PLANNING BOARD MEETING

Lansing Town Hall Board Room Monday, October 27, 2025 6:30 PM

<u>d.</u> **Project:** Site Plan Review – 164 Auburn Road

Mr. John Zepko Director of Planning & Code Enforcement Town of Lansing 29 Auburn Road Lansing, NY 14882

C-106

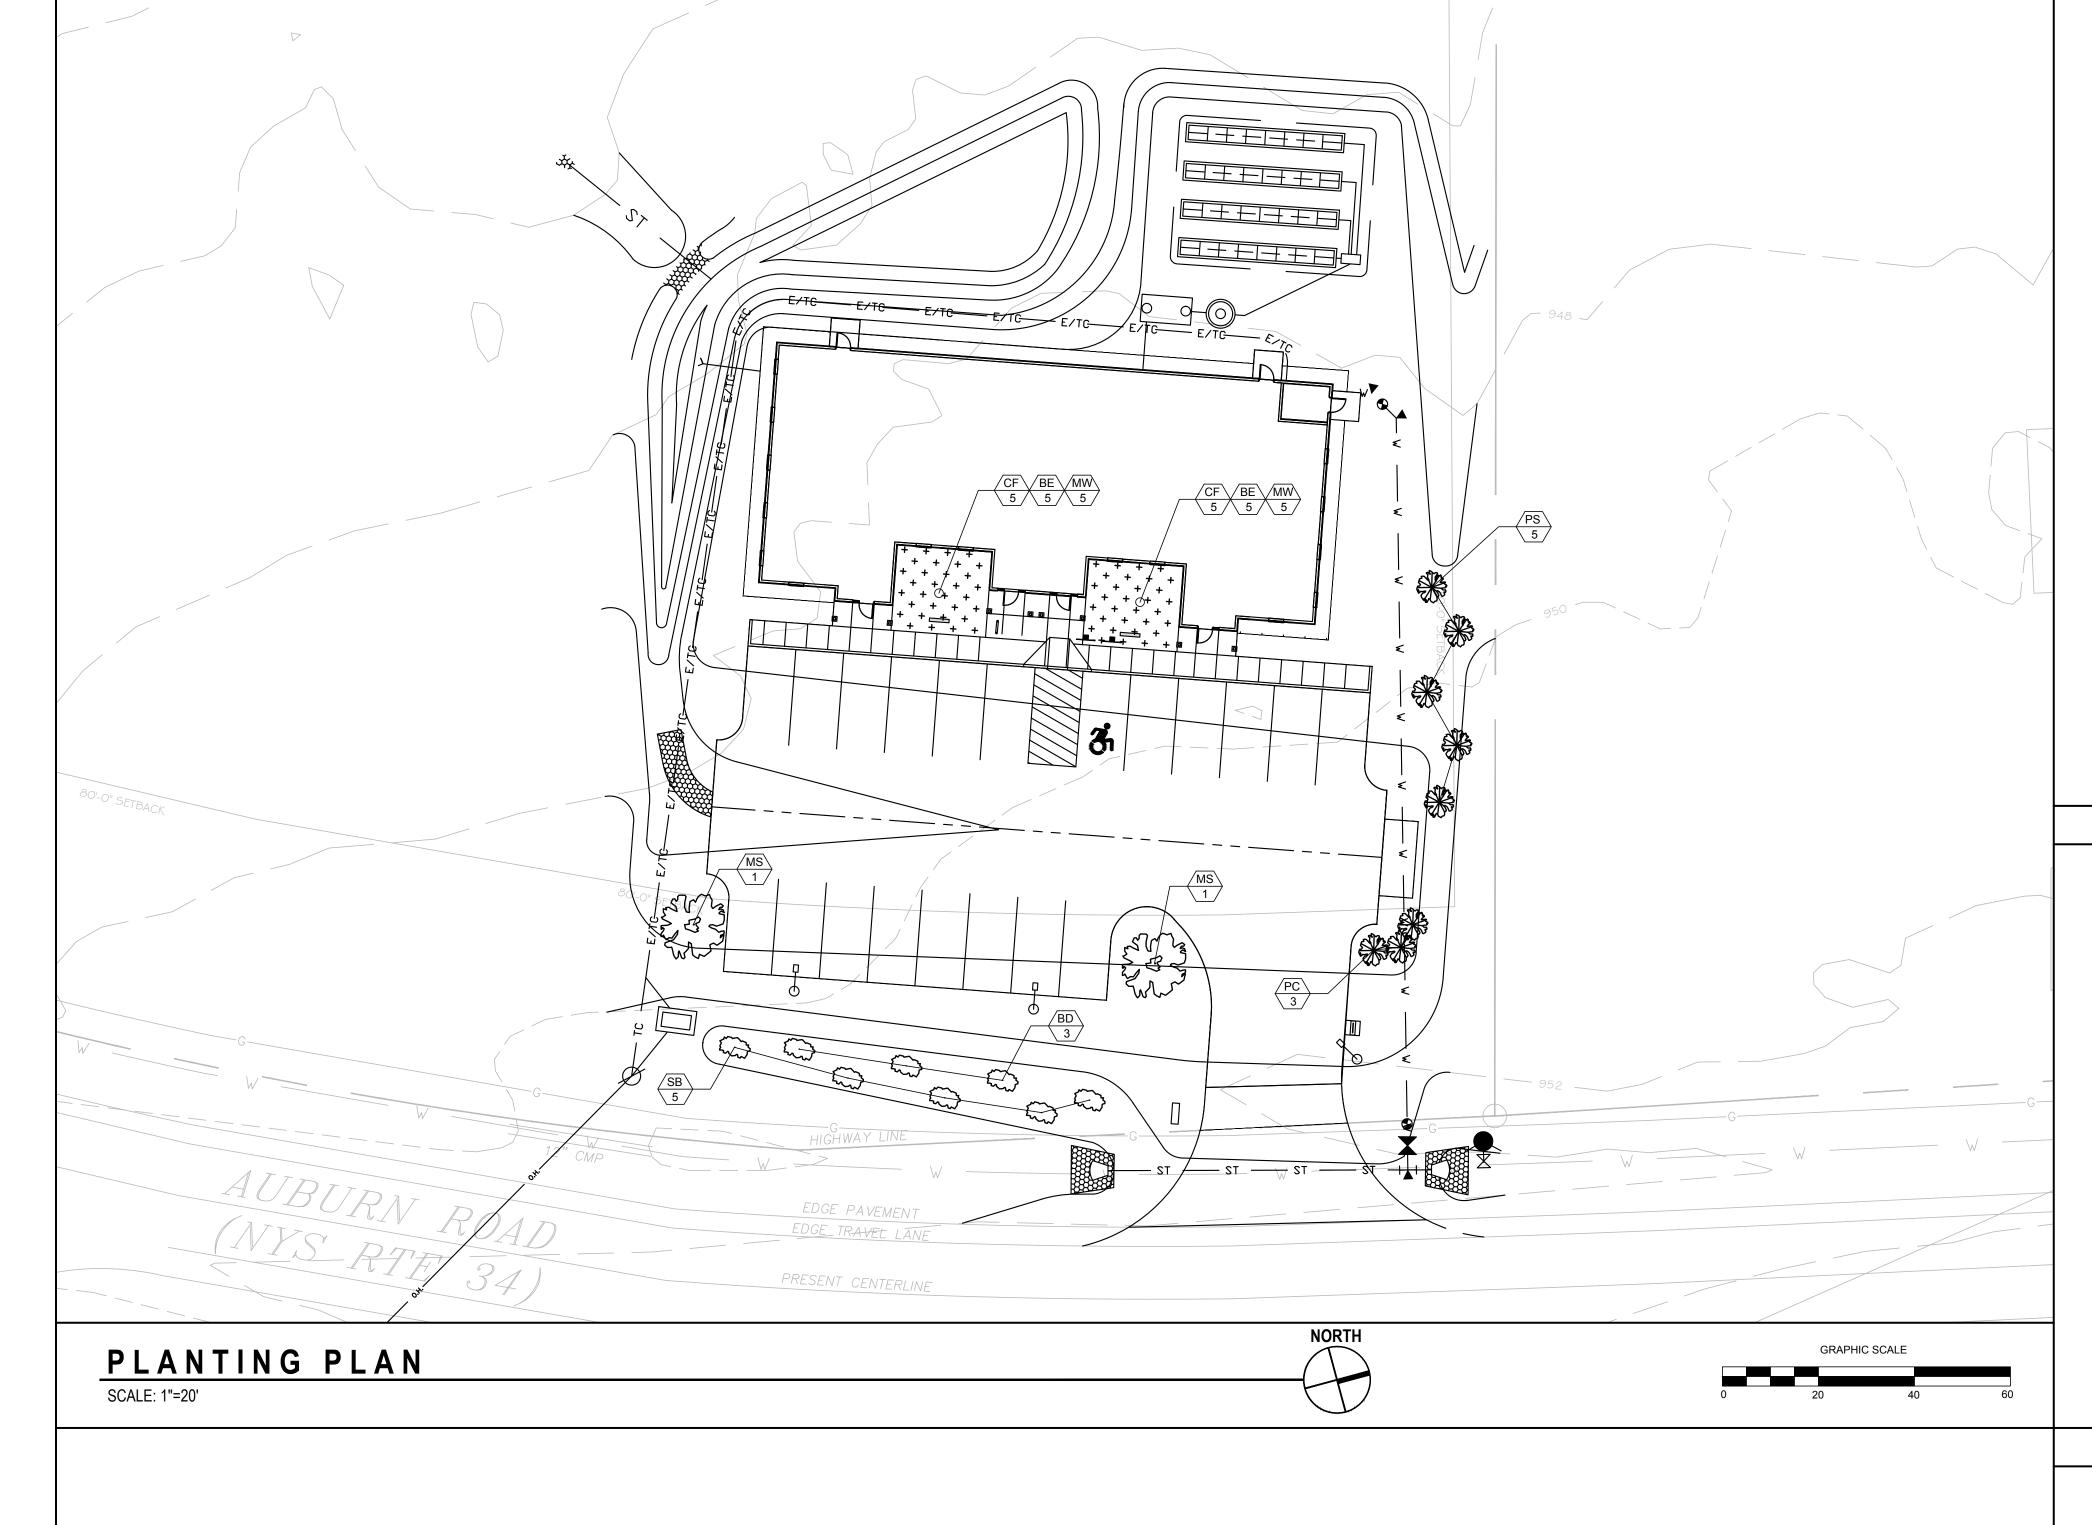
- Please provide a landscaping plan per the site plan application checklist, § 270-40.1 and §270-27 H.
 (9). of the zoning code. Additional guidance can be found in §270 attachment 8 "Town of Lansing Buffer Chart".

- Proposed plantings and a plant schedule were included on drawing C-103 "Site Plan and Details" as part of the original submission dated May 27, 2025. At the June 23, 2025, meeting the Planning Board requested additional plantings be added along the north property line to screen the parking lot from the neighbors to the north. They also requested low shrubs be

added to the berm located east of the parking lot. Drawing C-106 "Planting Plan and Details" has been added to the drawing set showing the additional plantings.
